**GRANTSVILLE CITY
RESOLUTION NO. 2021-45**

To Kristy Clark, Grantsville City Planning and Zoning Administrator
From Shay Stark, Contract City Planner
Date June 4, 2021
CC 
Subject Peak Crossings Subdivision Phase 1 – Final Plat – Planning Commission Memo.

To Kristy Clark, Grantsville City Planning and Zoning Administrator
From Shay Stark, Contract City Planner
Date April 19, 2021 **Updated May 26, 2021**
CC
Subject Peak Crossings Phase 1 (Formerly Hawthorne Estates) – Final Plat – **2nd** Review

**PEAK CROSSINGS
PHASE 1
OVERALL SITE PLAN**

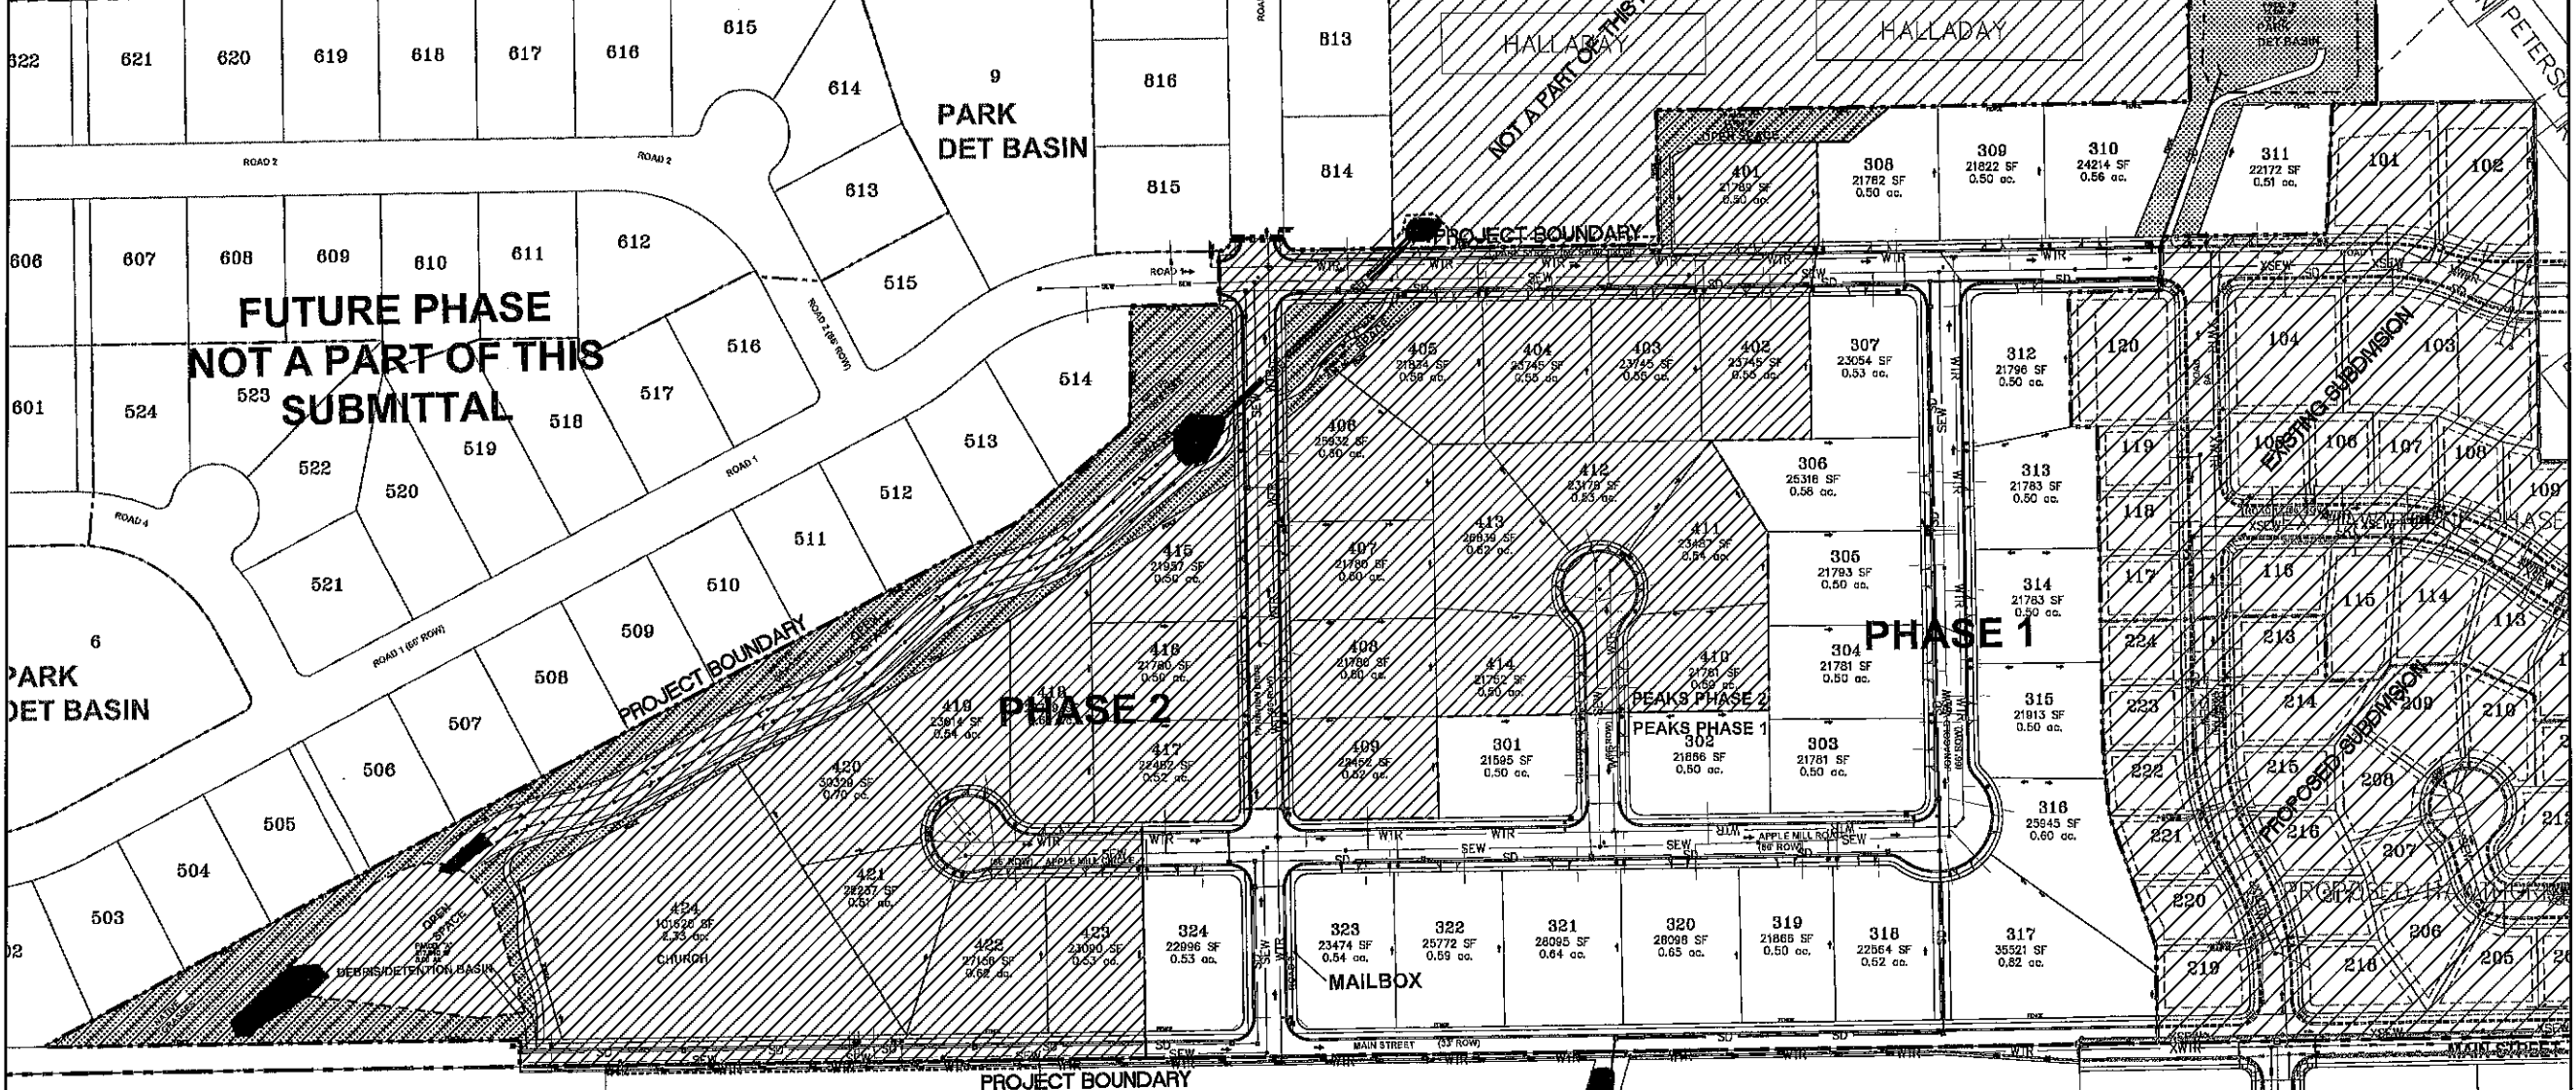
- Sheet 2 Overall Site Plan (bottom center), Sheets G1 – G4 Grading and Drainage Plan (top right corner G1-2) (top left G-3) (bottom right G-4): Change the word State to City on the Encroachment Permit Note. **(Complete)**
